Item ID: D145-762-043 Accept *N900040100* Setup Start *NS1*
Revision ID: Stop *NS2*
Item Name: Replacement Std Skidtube
Start Date: 5/18/2016 Start Qty: 1.00 *1* Cust Item ID:
Required Date: 5/18/2016 Req'd Qty: 1.00 *1* Customer:
Reference: INSTALL DSI 9731-011 Rawork

Item ID: D145-762-043 Accept ***N900040100*** Setup Start ***NS1***
Revision ID: Stop ***NS2***
Item Name: Replacement Std Skidtube
Start Date: 5/18/2016 Start Qty: 1.00 ***1*** Cust Item ID:
Required Date: 5/18/2016 Req'd Qty: 1.00 ***1*** Customer:
Reference: REWORK D4680-041 TO REV E/DSI 9731-011

DART SERVICE INSTRUCTION

TO AMEND INSTALLATION INSTRUCTIONS IIN-D117-762 REV. D AND
INSTRUCTIONS FOR CONTINUED AIRWORTHINESS ICA-D117-762 REV. 3

FIGURE 1 - GHU UPGRADE INSTALLATION

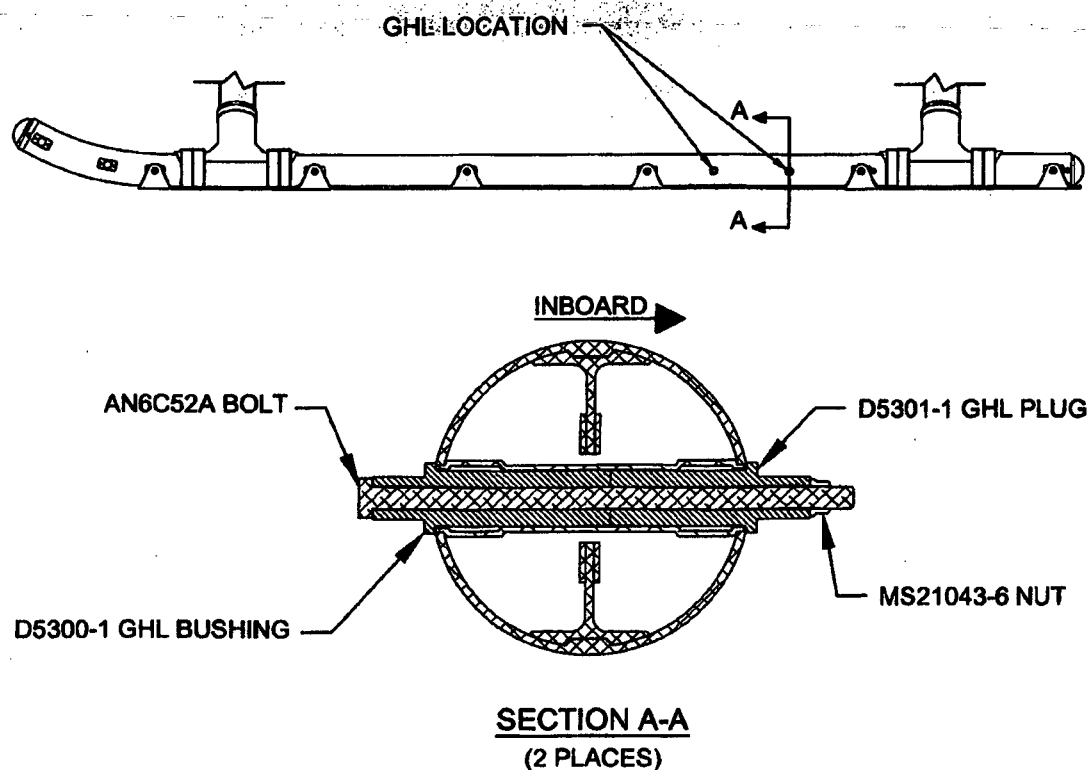
The purpose of this Dart Service Instruction (DSI) is to replace the ground handling lugs (D3864-1 Bushings, AN6C51A Bolts and MS21043-6 Nuts) on the D145-762-XXX Skid tubes with a structurally superior lug design. This service instruction only affects D145-762-043/-013/-113 Skid tubes at change 004 or earlier and D145-762-045/-015/-115 Skid tubes at change 001. It is highly recommended to install DSI 9731-011 GHL Upgrade Kit in order to prevent early structural failure of the D145-762-XXX Skid tubes. Each DSI 9731-011 GHL Upgrade Kit provides the necessary parts and hardware for installation on one skid tube.

- 2.1 Remove (qty 4) D3864-1 Bushings per Skid tube by removing (qty 2) AN6C51A Bolts and (qty 2) MS21043-6 Nuts
- 2.2 Loosely install (qty 2) D5300-1 GHL Bushing & (qty 2) D5301-1 GHL Plug wet with Proseal 890 or MIL-S-8802 Class B2 Sealant in location shown in Figure 1.
- 2.3 Install AN6C52A Bolts and (qty 2) MS21043-6 Nuts in accordance with Figure 1. Clean up squeezed out Proseal and apply fillet seal around D5300-1 & D5301-1.
- 2.4 Torque AN6C52A Bolts 160 - 190 in-lbs (18.1 - 21.5 N-m).
